ADDRESS: 1600-18 ARCH ST, UNIT 1621

Proposal: Cut down window into door on terrace; install windows without muntins

Review Requested: Final Approval

Re: Amended Building Permit
The Phoenix, 1600 Arch Street, Unit 1621

Figure 1: Map showing location of terraces on the east of elevation of 1600-18 Arch Street (The Phoenix).

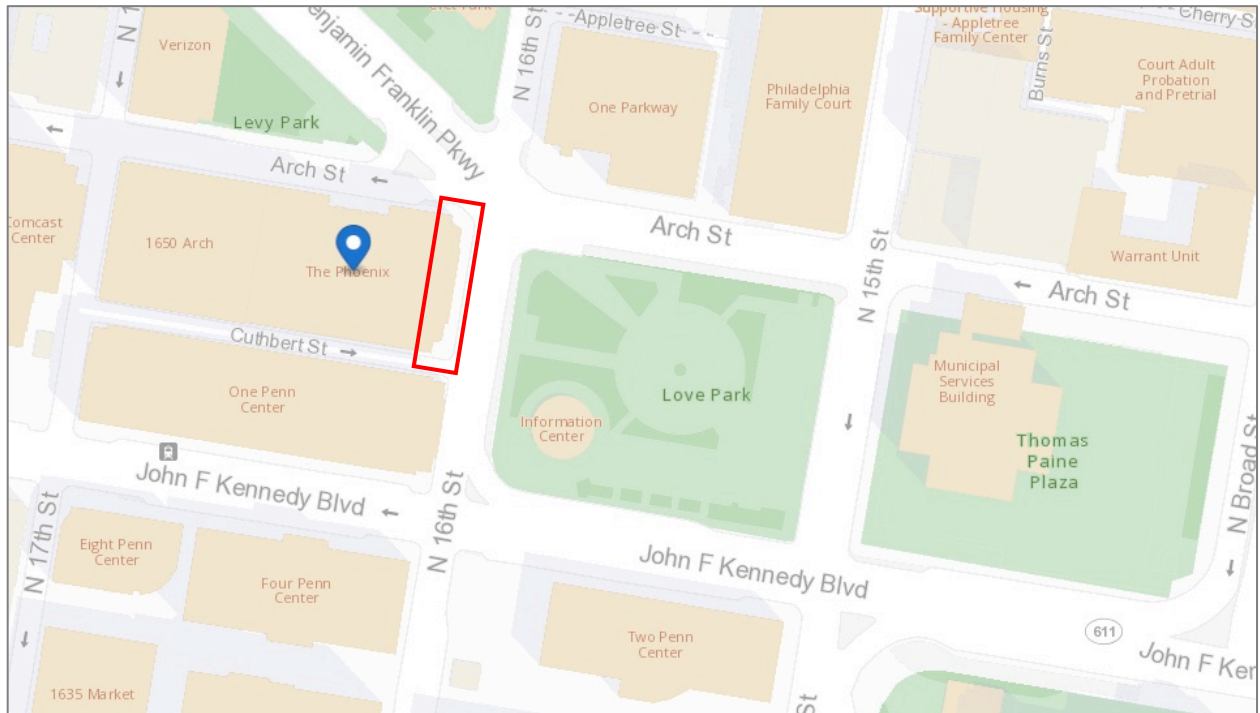
- While changing the doors to windows is acceptable, the historic muntin pattern should be maintained in the new windows, doors, and transoms to satisfy Standard 2.

- Owing to a lack of visibility from the public right-of-way, the removal of the window and cut down of the limestone masonry to accommodate a new door on the south terrace meets Standard 9.

- As the upper portion of the doors and transoms on the 16th floor's east elevation are visible from the public right-of-way, the historic muntin configuration should be maintained to satisfy Standard 9.

STAFF RECOMMENDATION: Denial pursuant to Standards 2 and 9.

SOUTH TERRACE

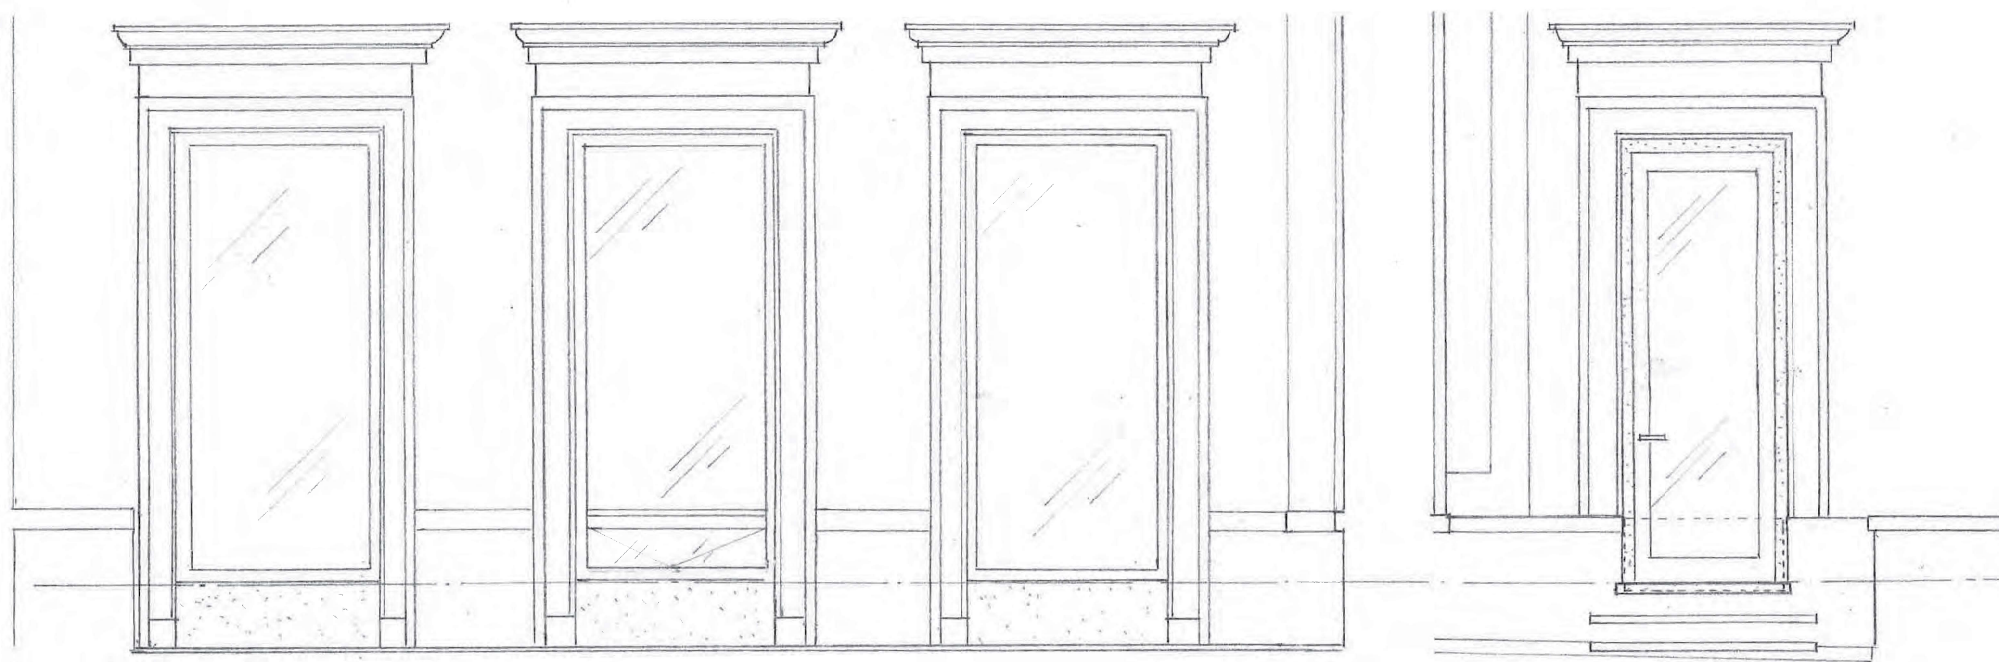
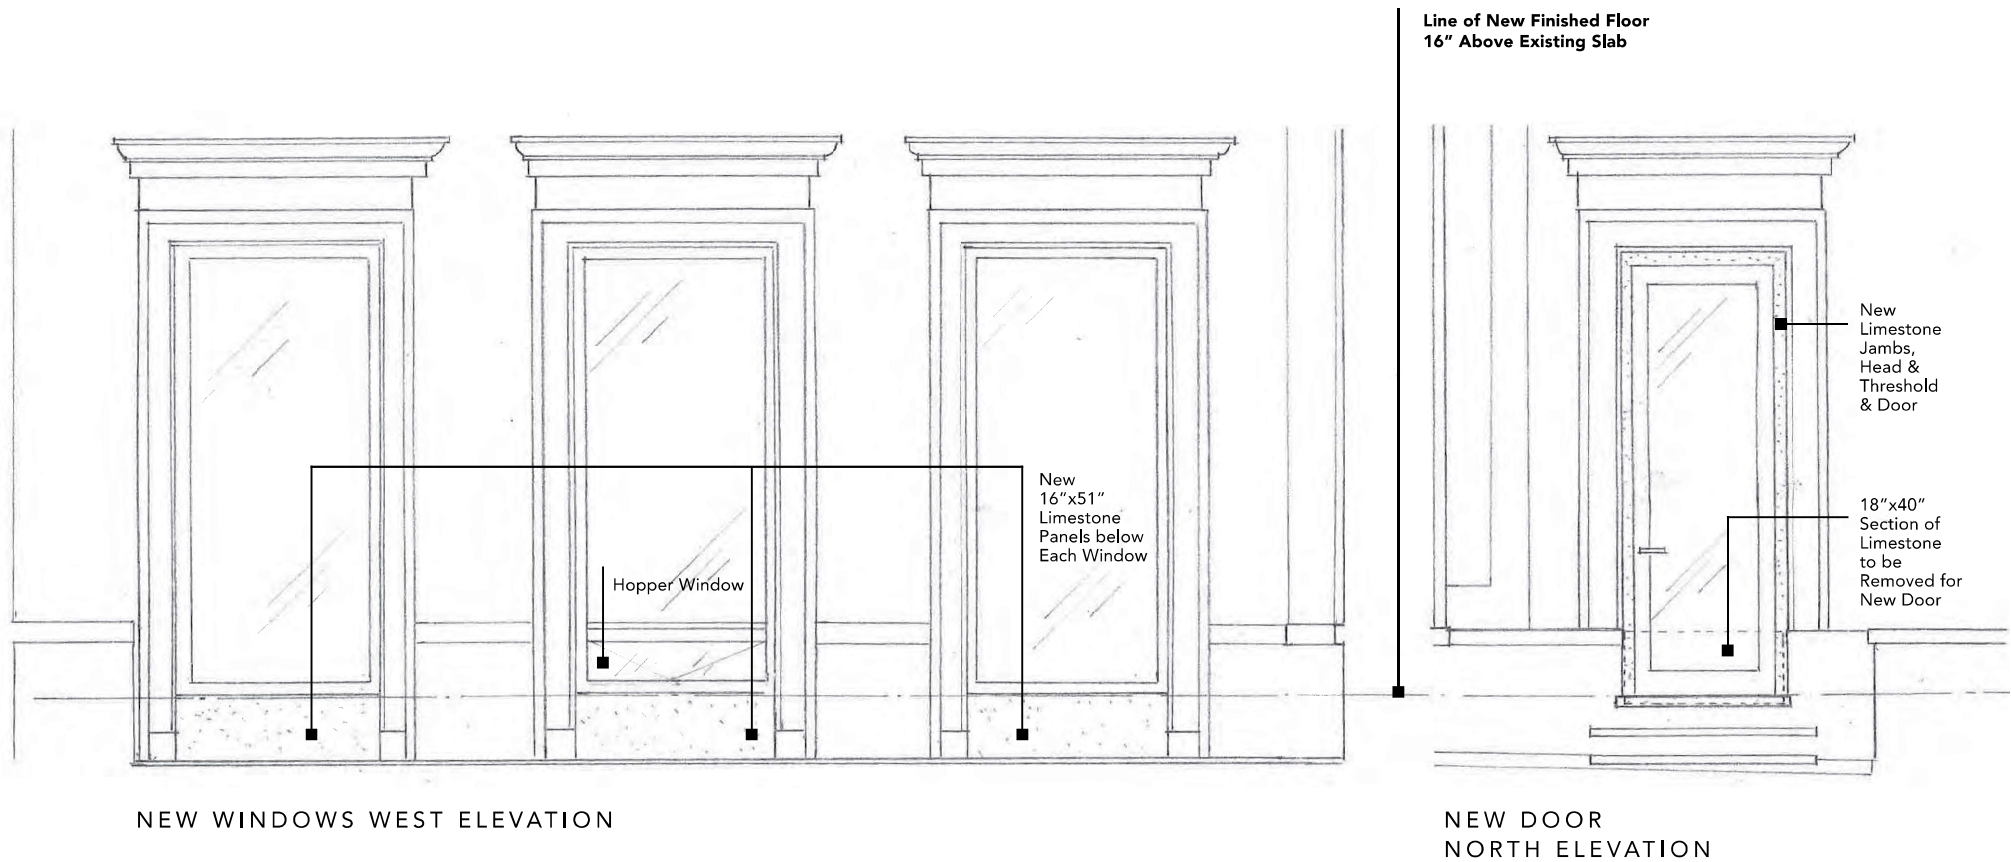
- ▶ Removal of the muntins shown in the seven windows to reflect the muntin-less appearance shown in Attachment 1: the windows are being replaced now in order to improve energy efficiency (the existing windows are drafty) and reduce exterior noise transmission into the unit. In addition, ground-level photographs of the unit windows found in Attachment 1 illustrate the limited ability to detect these muntin-divided lights from grade level. I am therefore requesting approval to eliminate these muntins for the reasons cited and to create a clean and contemporary interior appearance consistent with the entire interior and current market requirements for high-end rental units.

- ▶ Modification of the window between the Breakfast Area and the South Terrace to a door opening. This opening, which require removal of an 18" x 40" limestone panel below the sill of the existing window, allows for replacement with a new 3'-0" x 9'-0" door that is framed by new 2" thick limestone jambs, head and threshold that leave the existing limestone jambs and head of the window intact. An essential modification to this unit was to raise the finished floor by 16" in all areas outside of the living and dining areas in order to install new plumbing to the kitchen and baths on the south side of the unit, thereby avoiding damage to the ceilings and other finishes in Units 1516, 1518 and 1520 that are located below this unit (see Attachment 2 highlighting those

Drawing Title & Number
FLOOR PLAN

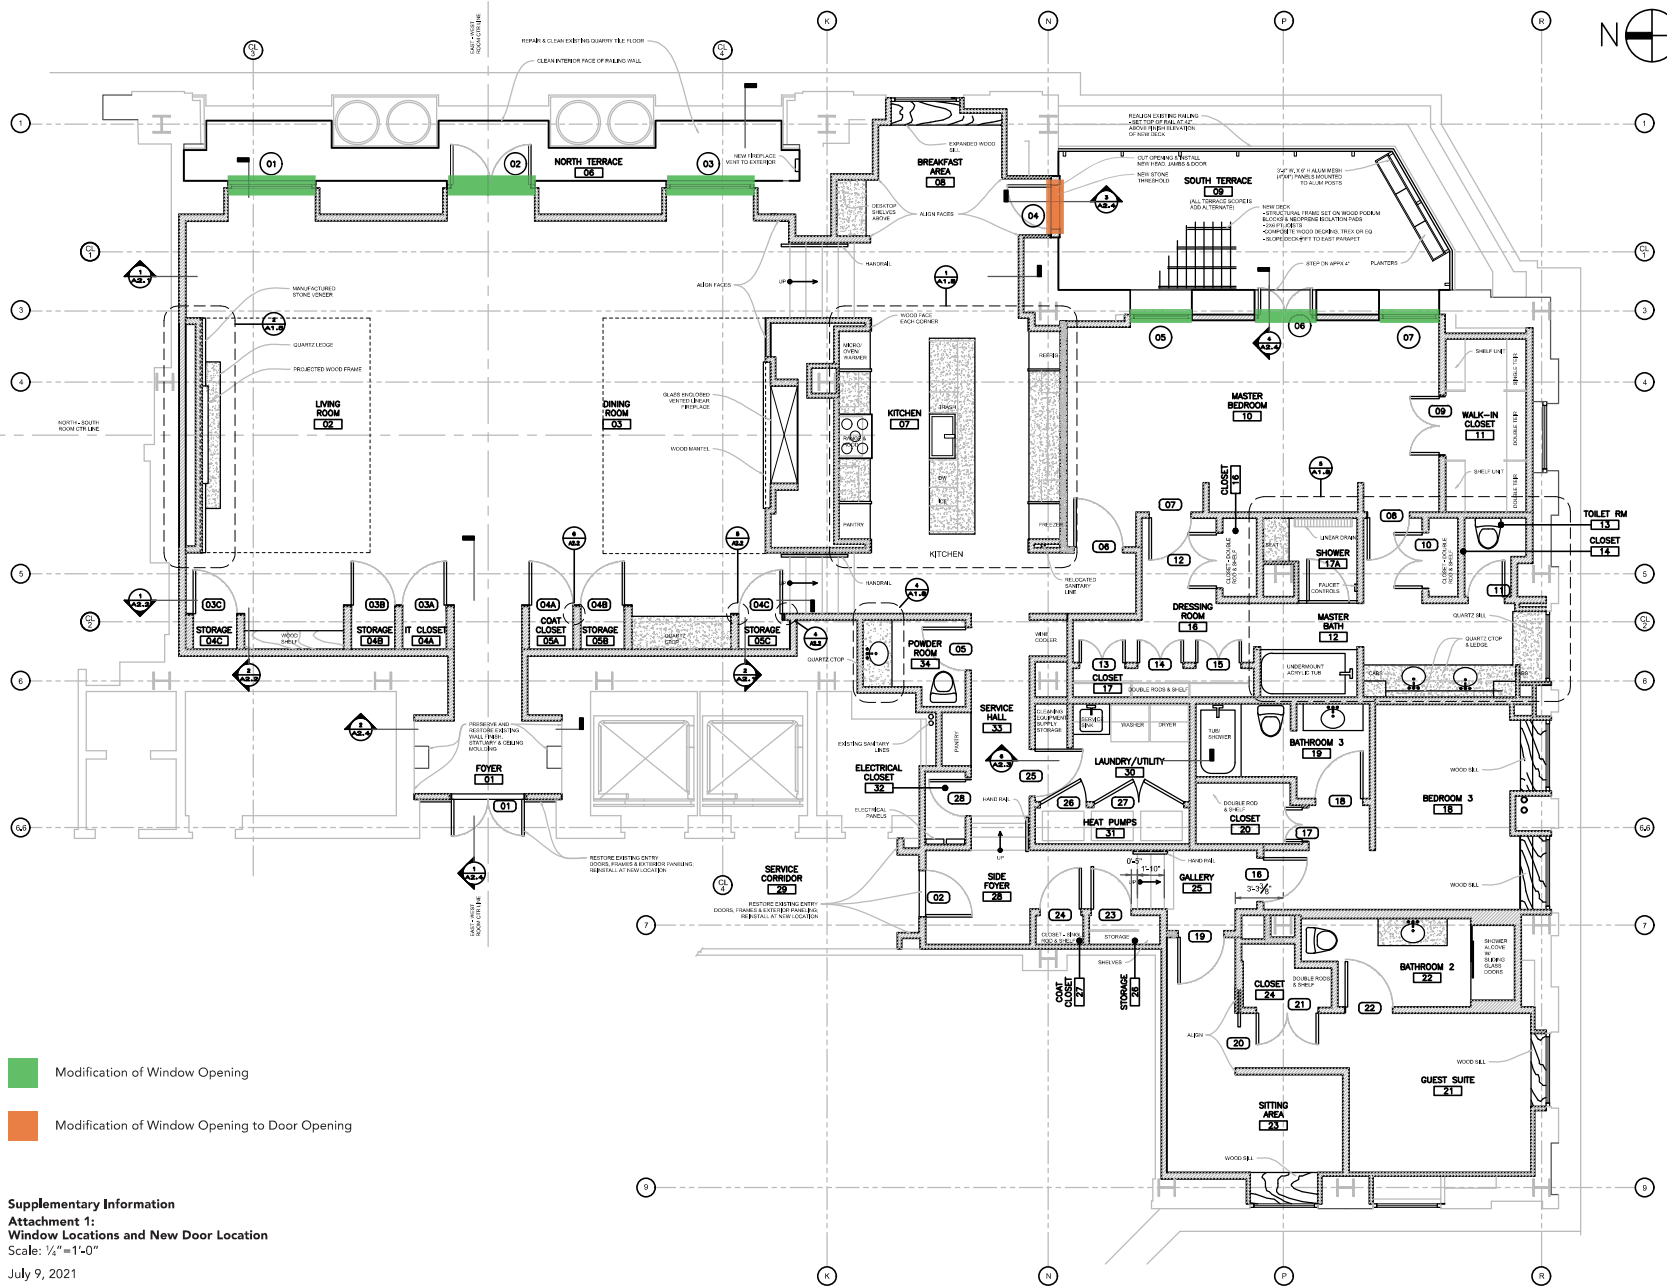
- Modification of Window Opening
- Modification of Window Opening to Door Opening
